Access Compliance Report

Public Rights-of-Way

(Curb Ramps)

Intersection ID: 13654	Main Street: S_TRYON_ST	Cross Street: W_PARK_AV	Location:	N
ADA ID: 5F37D66768F9	Ramp Type: Perp	Initial Pass/Fail: Fail	Overall Compliance: No	Severity Score: 12.5

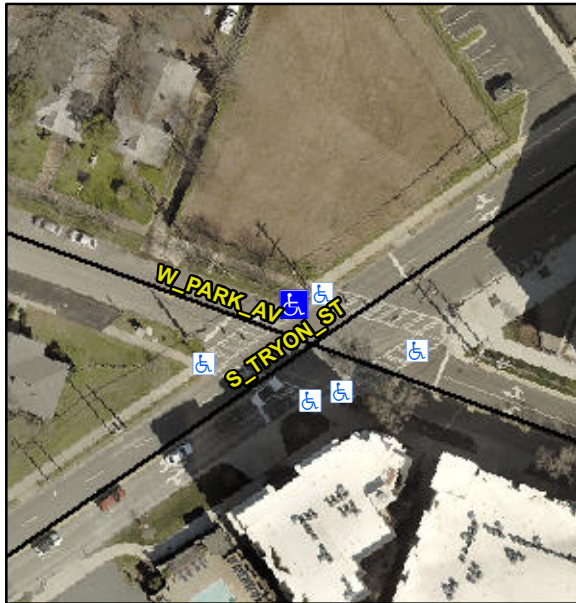
Not Found, R304.5.3

Compliance	Description	Data	Compliance	Description	Data
N/A	Ramp Length (in)	124.0	Yes	Ramp Slope (%)	7.7
Yes	Ramp Width (in)	55.0	No	Ramp XSlope (%)	5.2
N/A	Flare Type LT	N/A	N/A	Flare Type RT	N/A
N/A	Flare Slope LT (%)	N/A	N/A	Flare Slope RT (%)	N/A
N/A	Flare Traversable LT?	N/A	N/A	Flare Traversable RT?	N/A
N/A	Landing Length (in)	N/A	N/A	DWS Provided?	N/A
N/A	Landing Width (in)	N/A	N/A	DWS Contrast?	N/A
N/A	Landing Slope (%)	N/A	N/A	DWS Length (in)	N/A
N/A	Landing X Slope (%)	N/A	N/A	DWS Full Width?	N/A
N/A	Landing Curb? (Y/N)	N/A	N/A	DWS Offset (in)	N/A
N/A	Shared Landing?	N/A			
N/A	Gutter Ponding?	N/A	N/A	Gutter Slope (%)	N/A
N/A	Gutter Lip Ht (in)	N/A	N/A	Gutter X Slope (%)	N/A
N/A	Painted X Walk1?	Yes	N/A	Painted X Walk2?	N/A
	X Walk 1 Direction	To SW		X Walk 2 Direction	N/A
N/A	X Walk 1 Width (in)	104.0	N/A	X Walk 2 Width (in)	N/A
	X Walk 1 Slope (%)	0.2		X Walk 2 Slope (%)	N/A
	X Walk 1 X Slope (%)	2.7		X Walk 2 X Slope (%)	N/A

Remove & Replace Entire Ramp.
